Dockets Nos. 50-325  
and 50-324

The Commission has issued the enclosed Amendment No. <sup>24</sup> to Facility Operating License No. DPR-71 and Amendment No. <sup>48</sup> to Facility Operating License No. DPR-62 for the Brunswick Steam Electric Plant (BSEP), Units Nos. 1 and 2, respectively.

BRUNSWICK STEAM ELECTRIC PLANT, UNIT NO. 2

Amendment No. 48  
License No. DPR-62

FIGURE 3.2.1-1

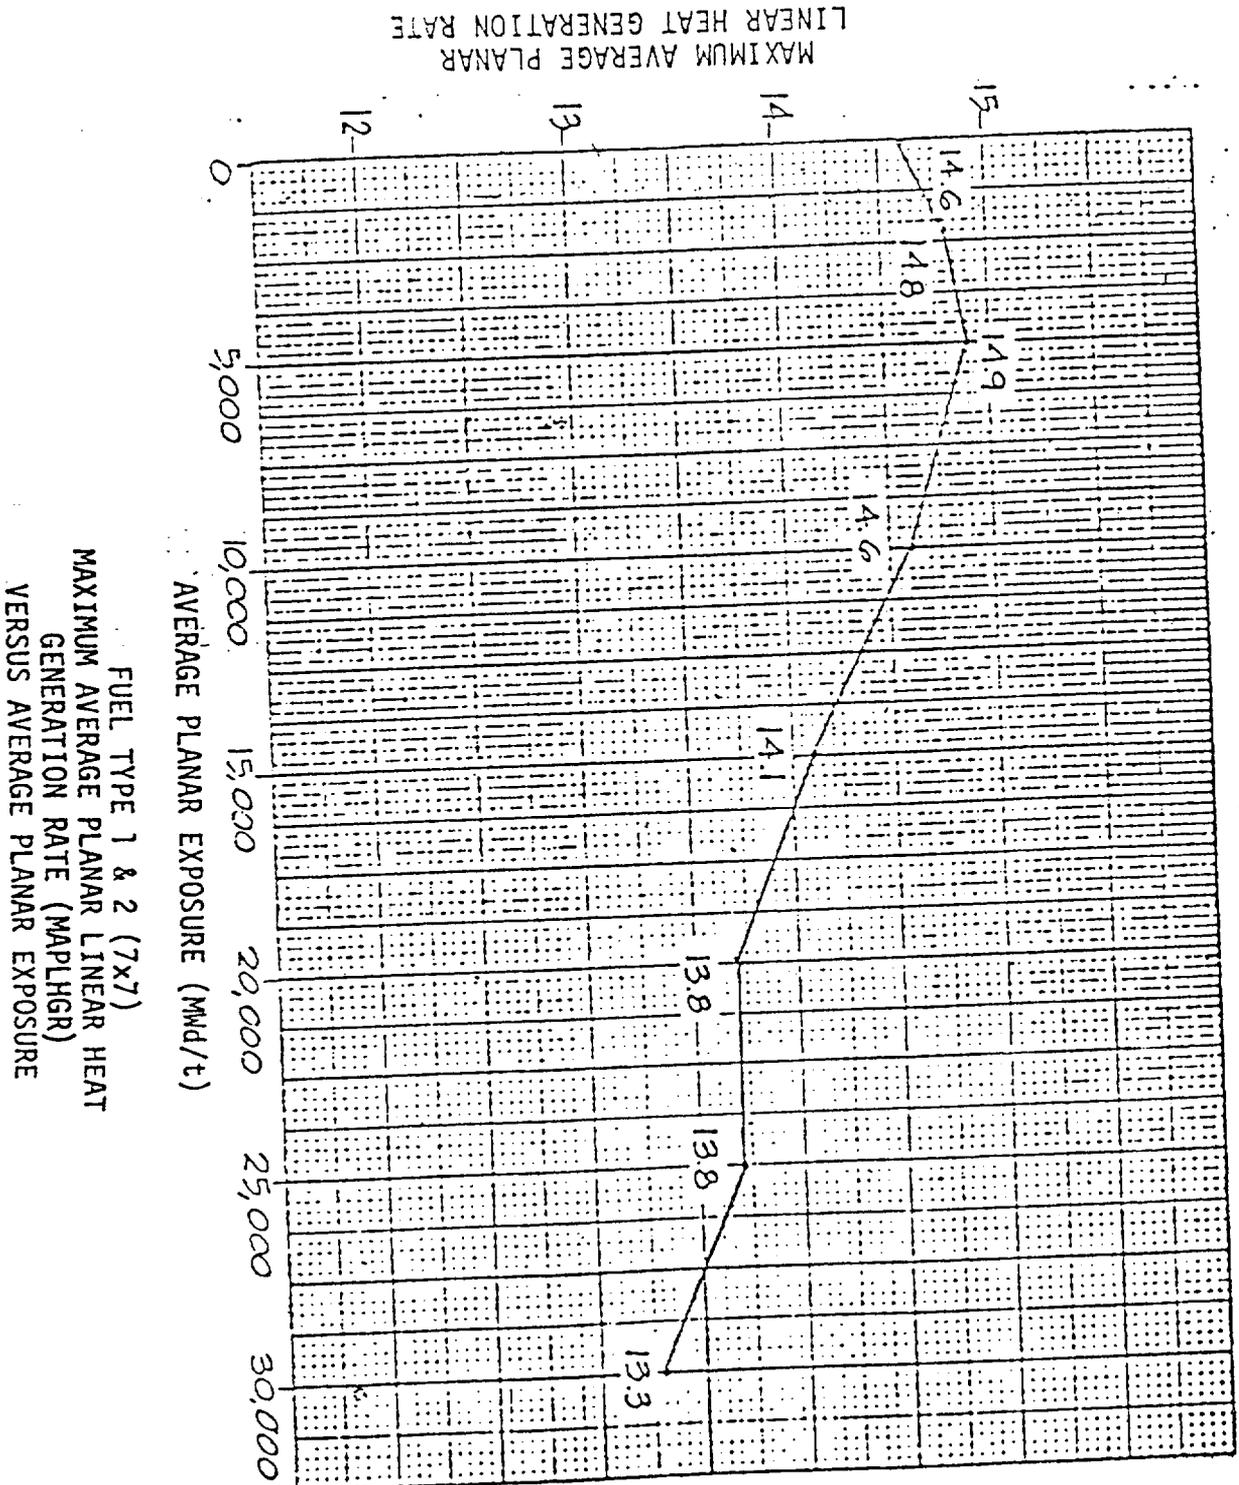
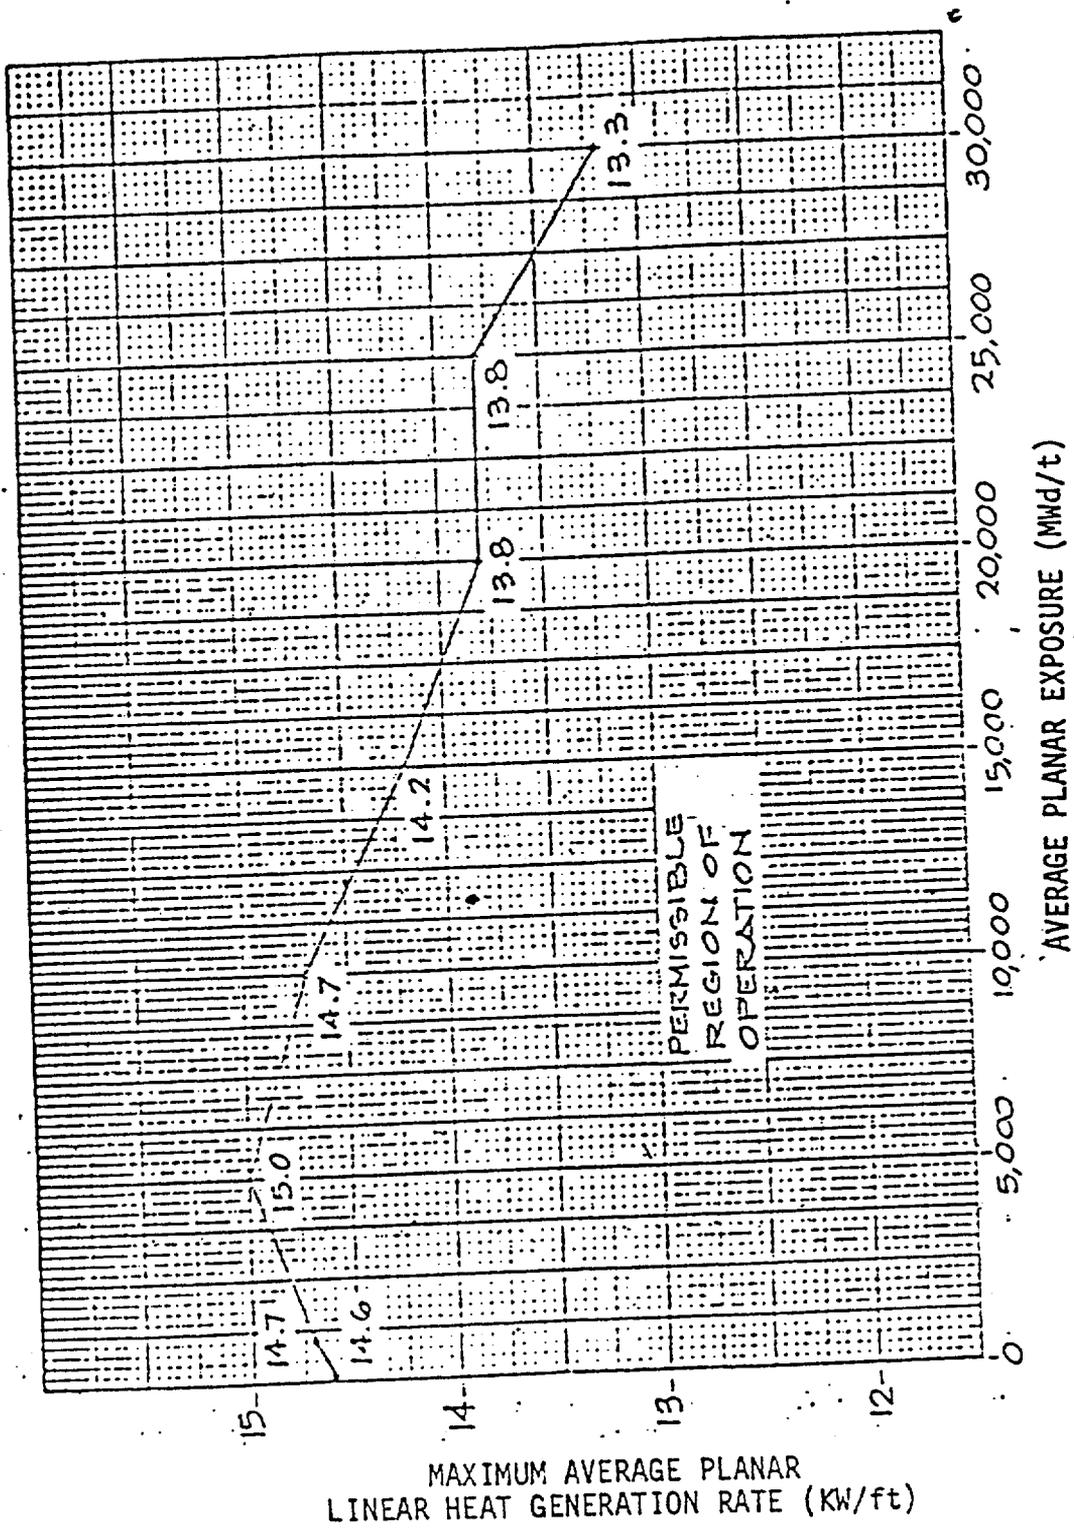
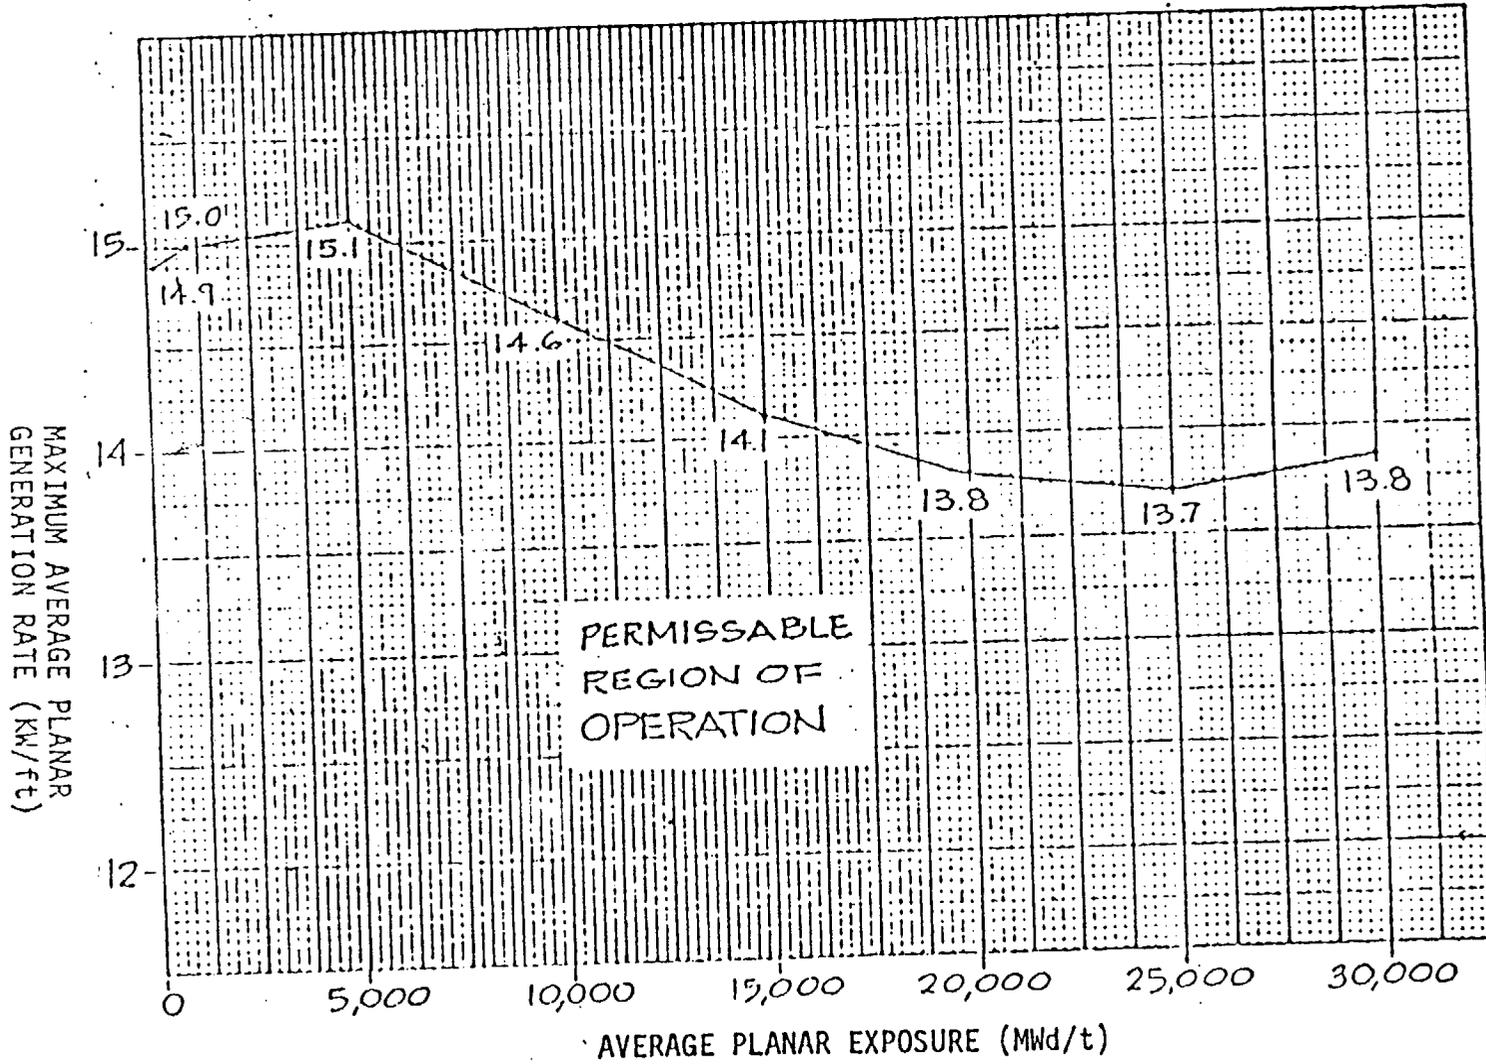
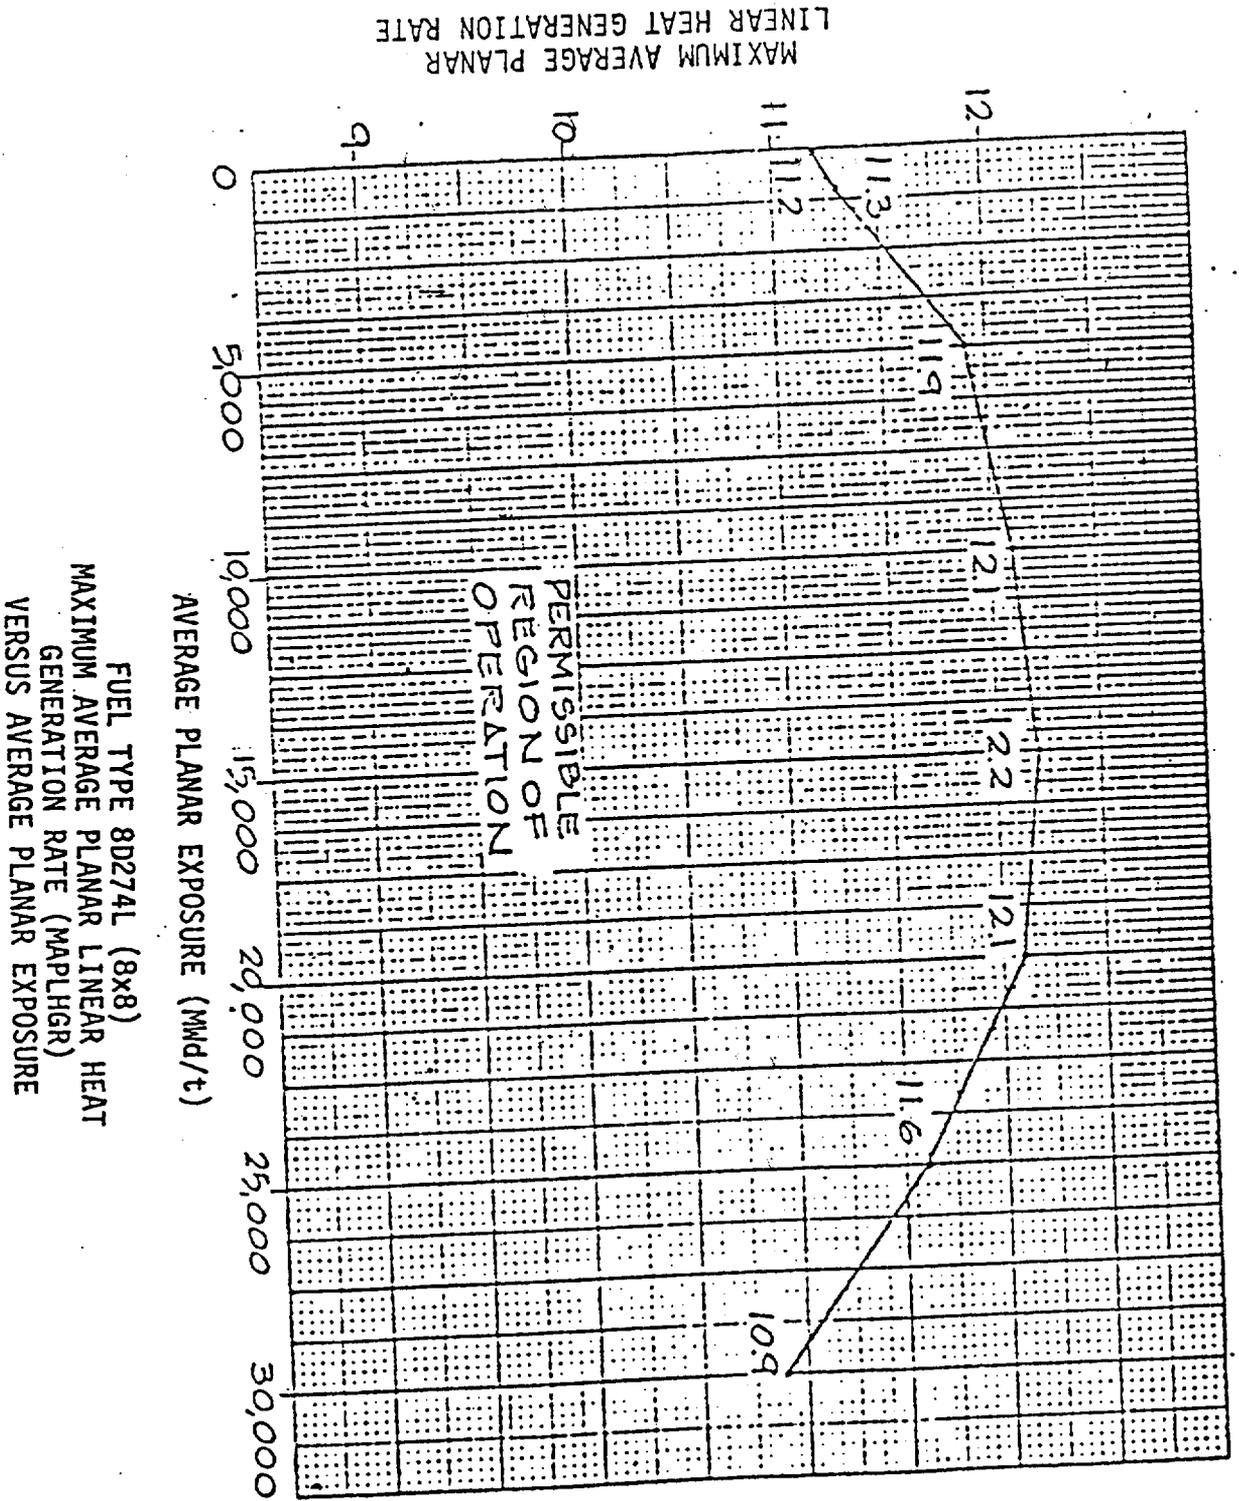
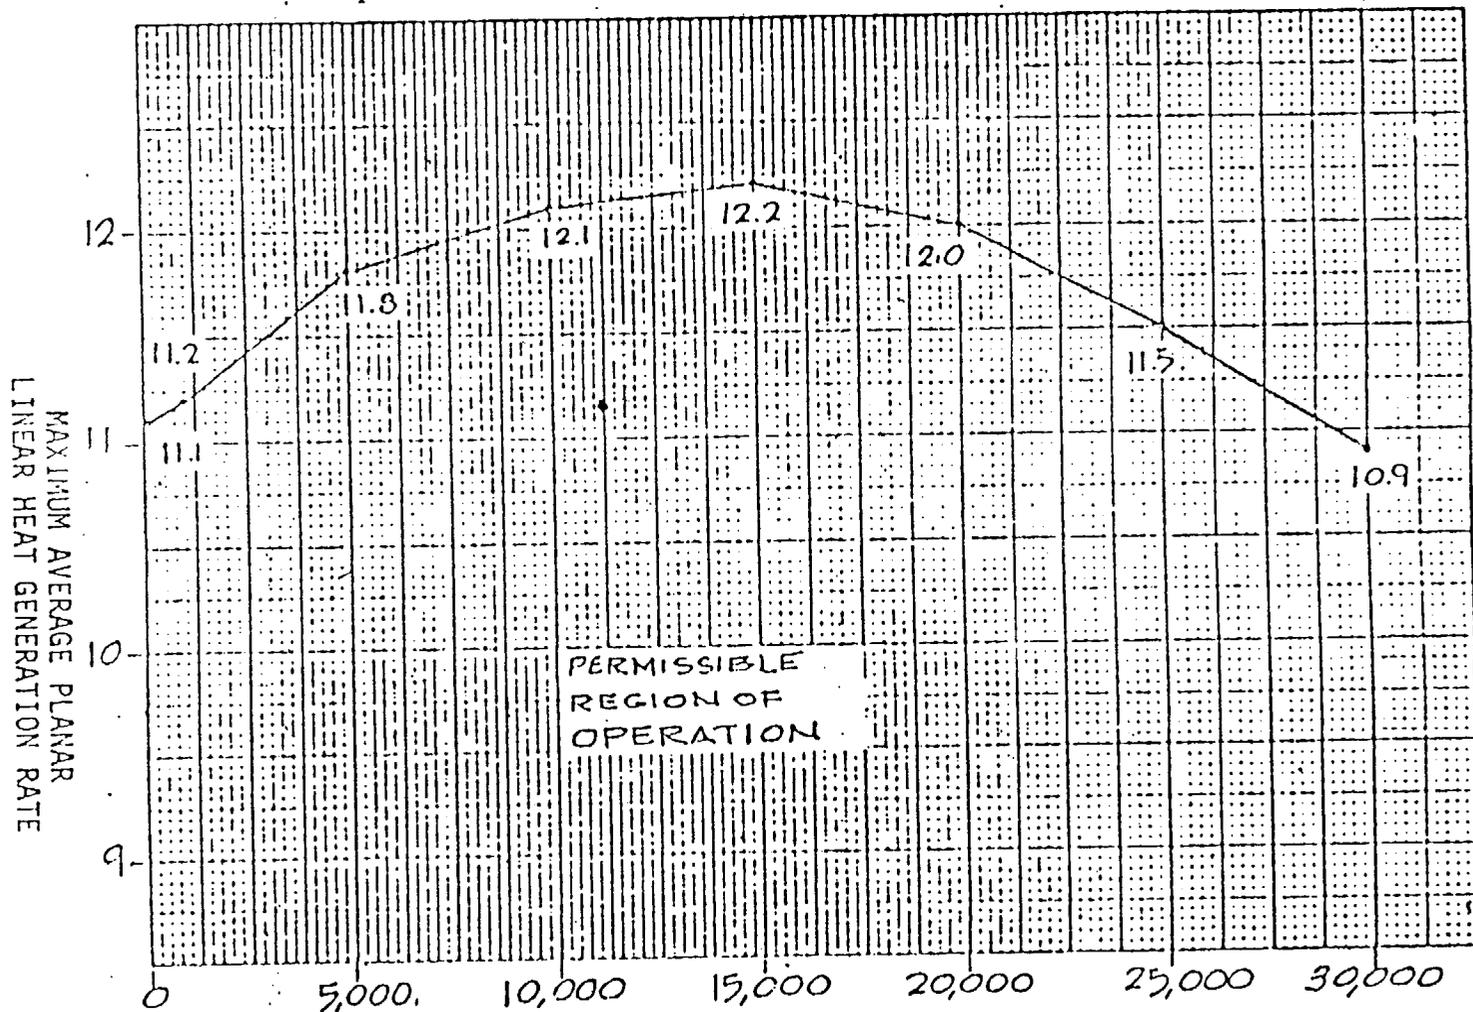
3.2.1 All AVERAGE PLANAR LINEAR HEAT GENERATION RATES (APLHGR's) for each type of fuel as a function of AVERAGE PLANAR EXPOSURE shall not exceed the limits shown in Figures 3.2.1-1, 3.2.1-2, 3.2.1-3, 3.2.1-4, 3.2.1-5, 3.2.1-6 or 3.2.1-7.

We have reviewed the information submitted by the licensee and conclude that all requirements of 10 CFR 50.46 and Appendix K to 10 CFR 50.46 will be met when the reactor is operated in accordance with the MAPLHGR versus Average Planar Exposure values given in Figures 3.2.1-1, 2, 3, 4, 5, 6, and 7 of the Technical Specifications.
